ADDENDUM NO. 7 TO PROJECT NO. 44808

**CONSTRUCTION WORK, HVAC WORK, PLUMBING WORK, AND ELECTRICAL WORK
RENOVATE BUILDING NO. 5
STATE OFFICE BUILDING CAMPUS
1220 WASHINGTON AVENUE
ALBANY, NY**

January 8, 2014

SHEET TITLE:
STOREFRONT MAIN ENTRANCE AND SECURITY PORTAL
DRAWING NUMBER:
A-429.1

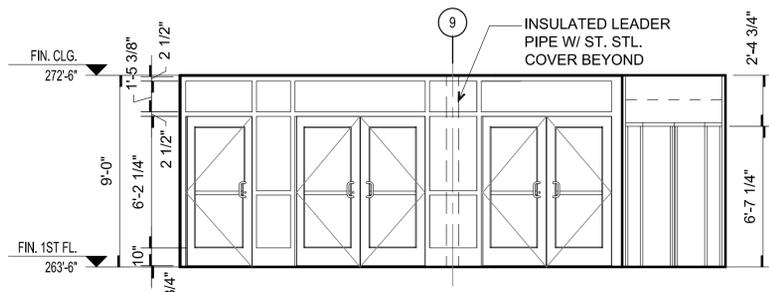
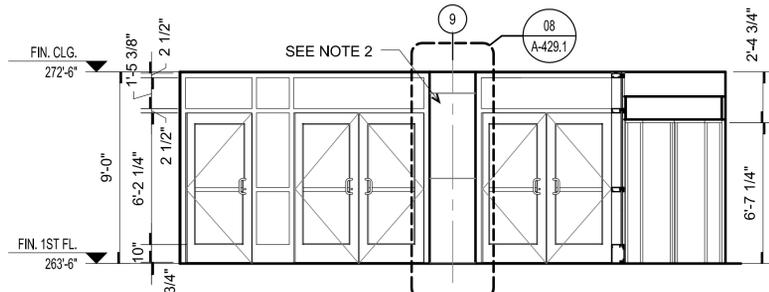
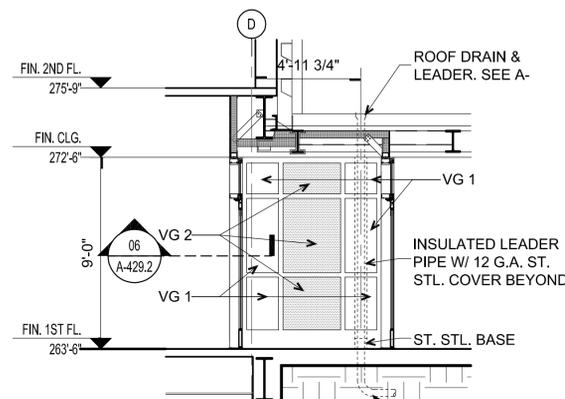
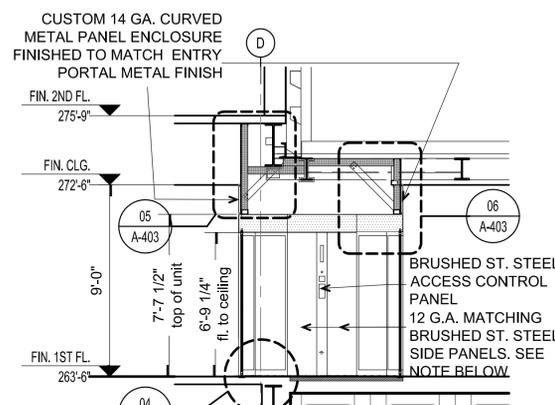
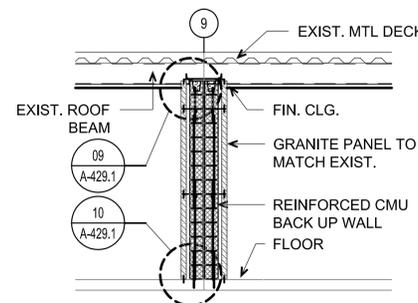
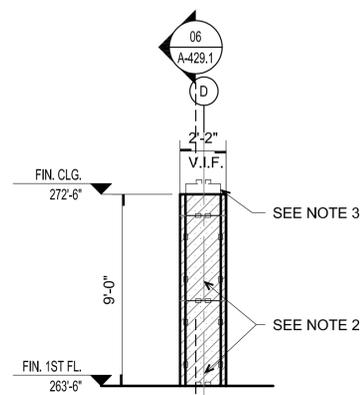
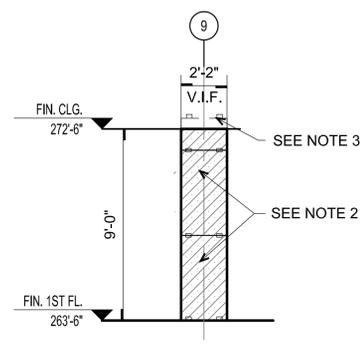
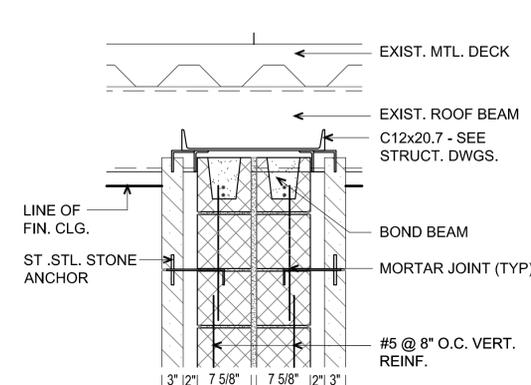
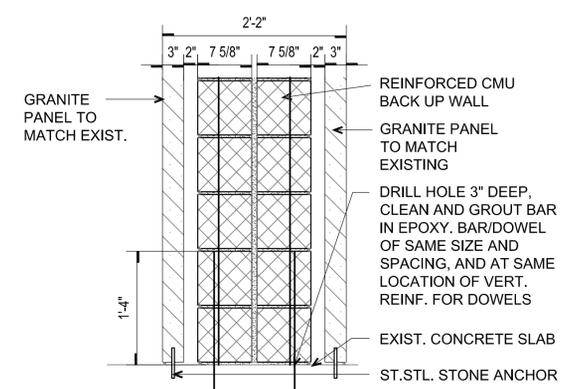
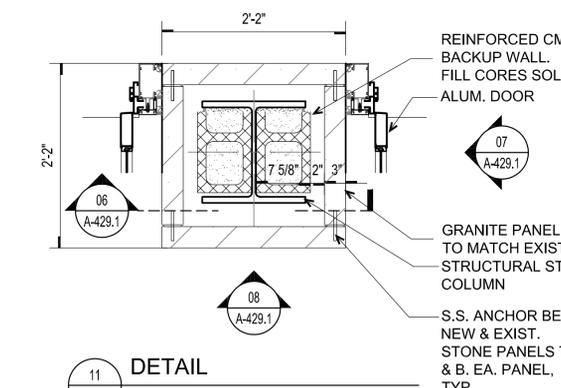
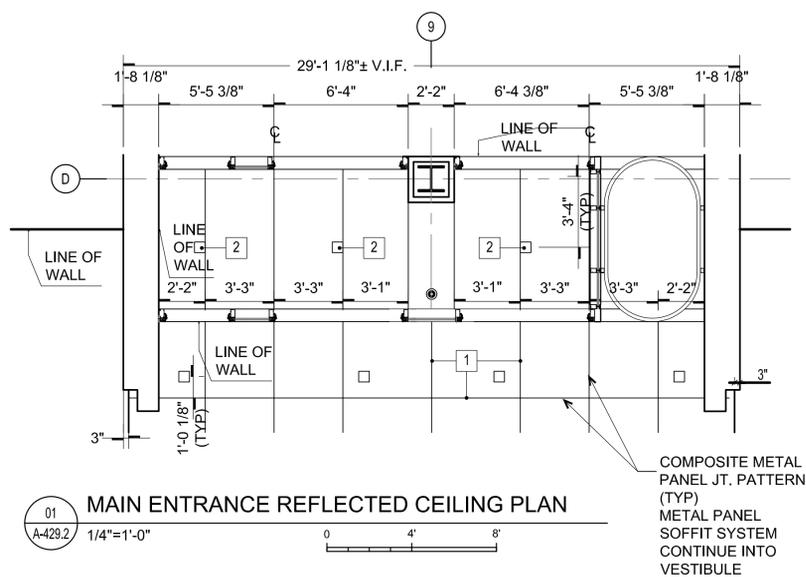
60. Revised Drawing Nos. A-102, A-111, and A-112 (dated 12/17/13), DOOR SCHEDULE: Change all references of "A-427" to read "A-429".
61. Drawing No. A-104, FIRST FLOOR PLAN, 01/A-104: Revise the entrance vestibule plan to match the Main Entrance Vestibule Floor Plan, 01/A-429.1.

62. Revised Drawing No. A-111 (dated 12/17/13), FIRST FLOOR PLAN – EAST, 1/A-111: Revise the entrance vestibule plan to match the Main Entrance Vestibule Floor Plan, 01/A-429.1.

75. Revised Drawing No. A-162(dated 12/17/13), DOOR SCHEDULE, Door 631: Change “EX” Door Type to read “B”.
76. Drawing No. A-201, NORTH ELEVATION, 01/A-201, and PARTIAL NORTH ELEVATION, 03/A-201: Revise the entrance vestibule elevation to match the revised Entry Vestibule Elevation (Outer Doors), 02/A-429.1.

77. Drawing No. A-405:
 - a. ENTRY – ENLARGED FLOOR PLAN, 1/A-405: Revise the entrance vestibule plan to match the Main Entrance Vestibule Floor Plan, 01/A-429.1.

- b. ENTRY – NORTH ELEVATION, 2/A-405: Revise the entrance vestibule elevation to match the Entry Vestibule Elevation (Outer Doors), 02/A429.1.
78. Drawing No. A-409.1:

89. Revised Drawing No. A-413 (dated 12/17/13), INTERIOR ELEVATIONS AT THE MAIN LOBBY, 2/A-413: Revise the third elevation to be similar to the Entry Vestibule Elevation (Inner Doors), 03A/A-429.1.

97. Drawing No. A-429:
 - a. MAIN ENTRANCE VESTIBULE FLOOR PLAN, 01/A-429: Revise to match the Main Entrance Vestibule Floor Plan, 01/A-429.1.
 - b. ENTRY VESTIBULE ELEVATION (OUTER DOORS), 02/A-429: Revise to match the Entry Vestibule Elevation (Outer Doors), 02/A-429.1.

DRAWING NUMBER:
A-429.2

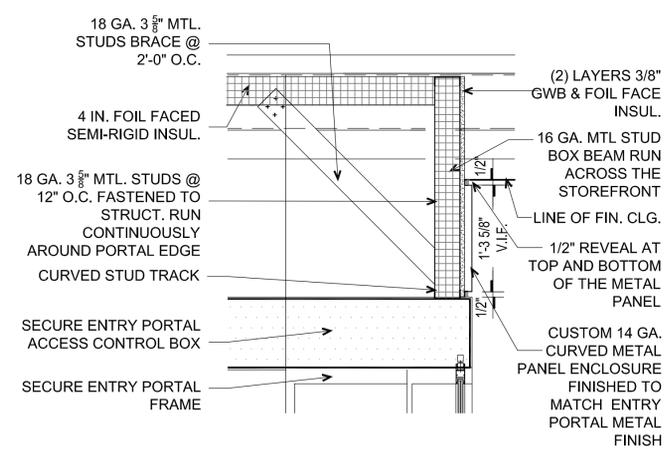
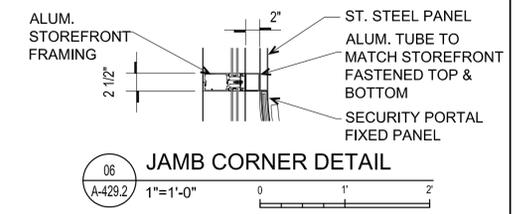
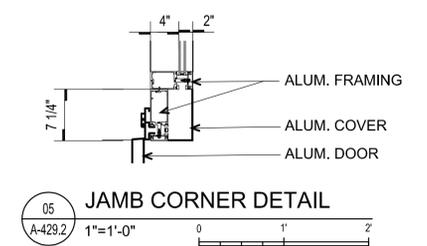
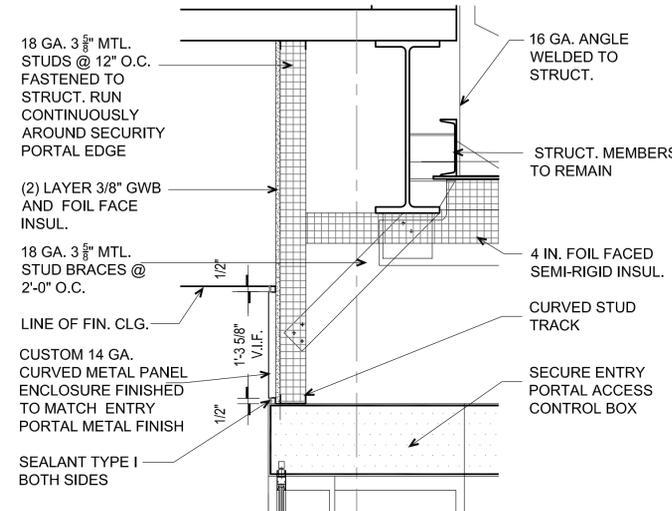
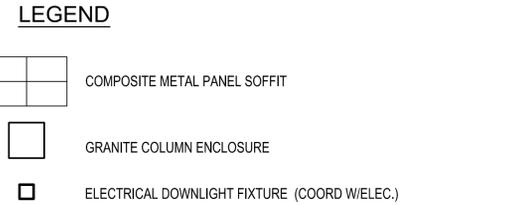
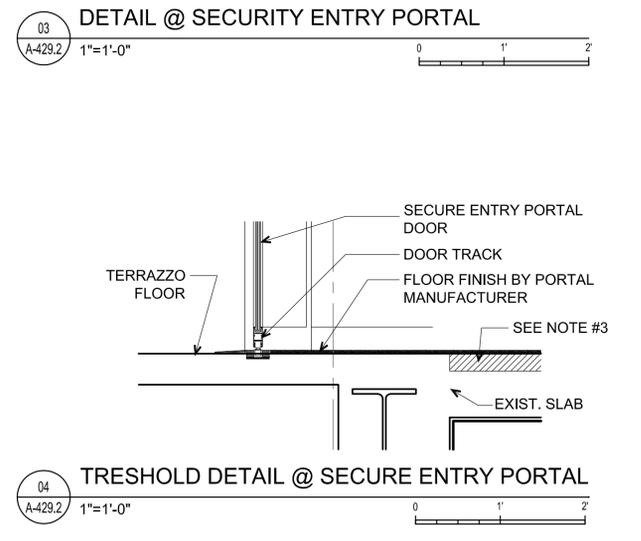
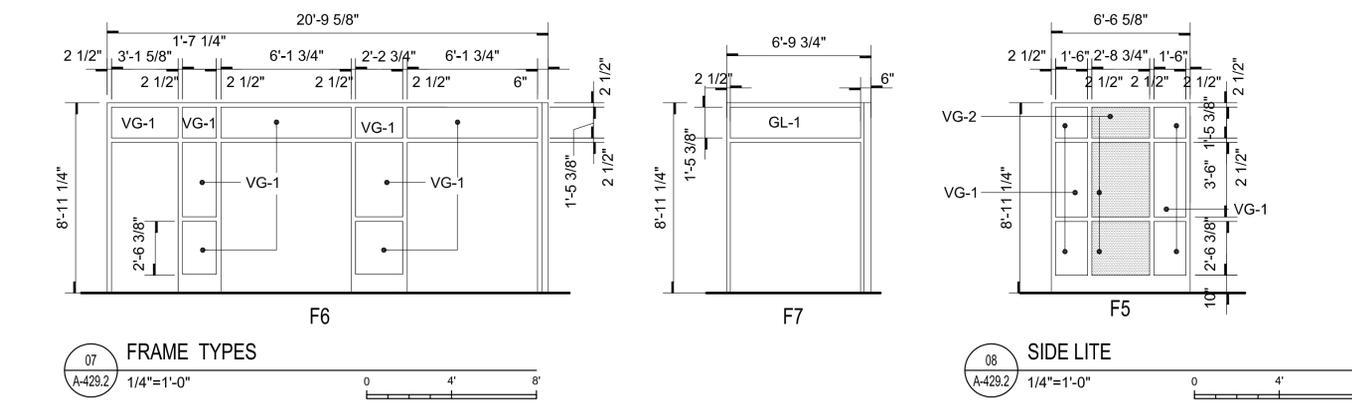
- a. Revise Drawing Key from “1/A-410” to read “1/A-409.1”.
 - b. CANOPY REFLECTED CEILING PLAN: Revise the entrance vestibule reflected ceiling plan to match the Main Entrance Reflected Ceiling Plan, 01/A-429.2.
